Carolina Power & Light Company

September 4, 1973

RE: DOCKET NO. 50-261

On July 30, 1973, Mr. William H. Regan, Jr., Chief, Environmental Projects Branch 4, transmitted a request to Carolina Power & Light Company for additional clarifying information relative to the H. B. Robinson Unit 2 environmental review.

LCD-1302

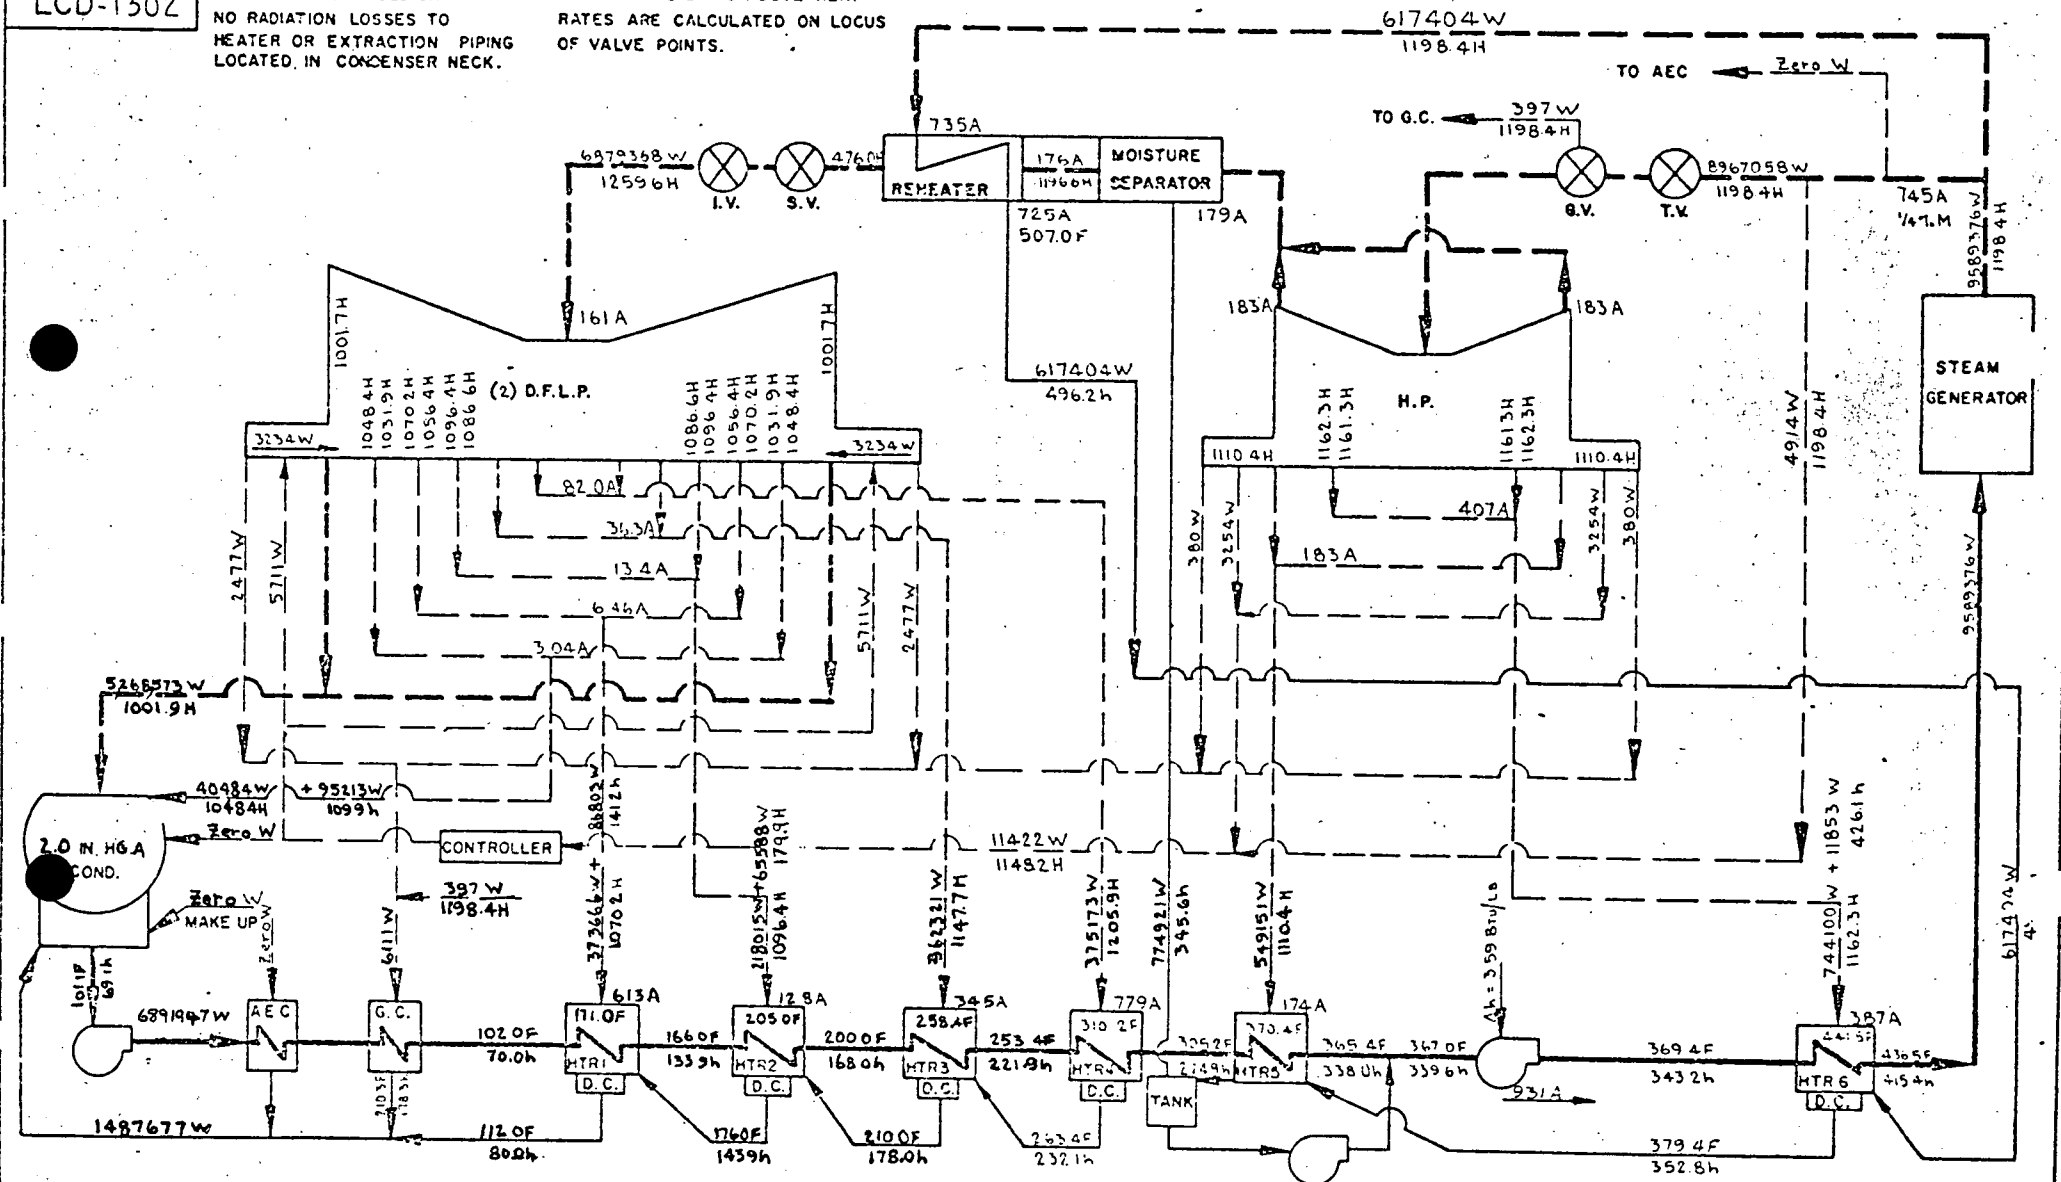
- 3) Enclosed as Appendix A to this letter is a heat balance for H. B. Robinson Unit 2 at 2200 MWt. Also enclosed is a heat balance at 2300 MWt which is the design power level used in the environmental review.
- 4) Attached as Appendix B to this letter is a copy of Carolina Power & Light Company's response to the South Carolina Pollution Control Authority's letter of June 7, 1973.
